Private Fuel Storage, L.L.C.

EIS COMMITMENT RESOLUTION LETTER #6
DOCKET NO. 72-22 / TAC NO. L22462
PRIVATE FUEL STORAGE FACILITY
PRIVATE FUEL STORAGE L.L.C.

Figure 19
Photo Location Map - Rail Siding Area

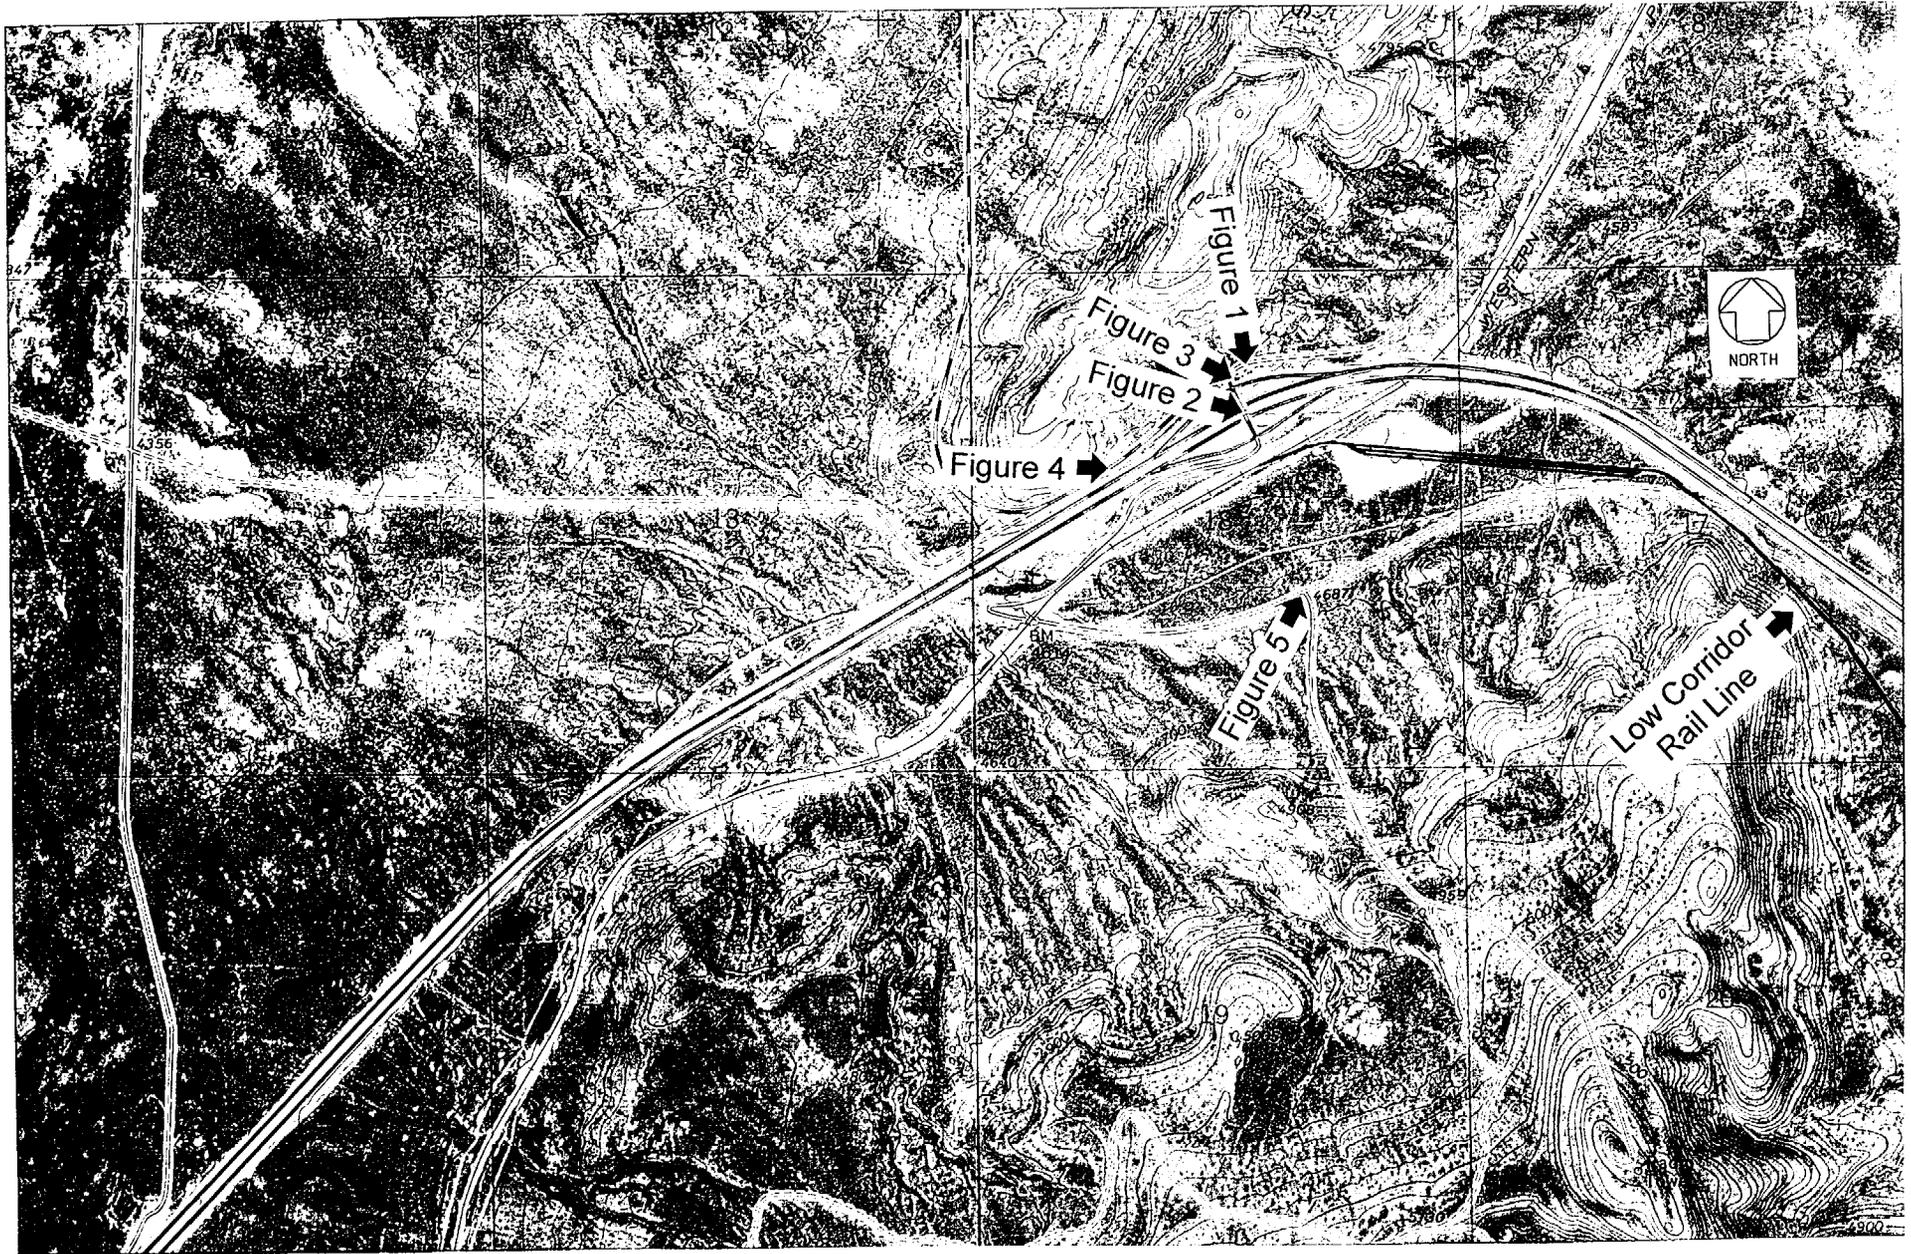
5. PFS should provide a map that shows the location where the photographs included in ER Chapter 4, Appendix 4A were taken. Each location on the map should include an arrow that shows the direction of the view presented.

RESPONSE – Figures 19, 20, and 21 are included as Attachment 3. These Figures show the location where the photographs included in ER Chapter 4, Appendix 4A were taken and include an arrow that shows the direction of the view presented.
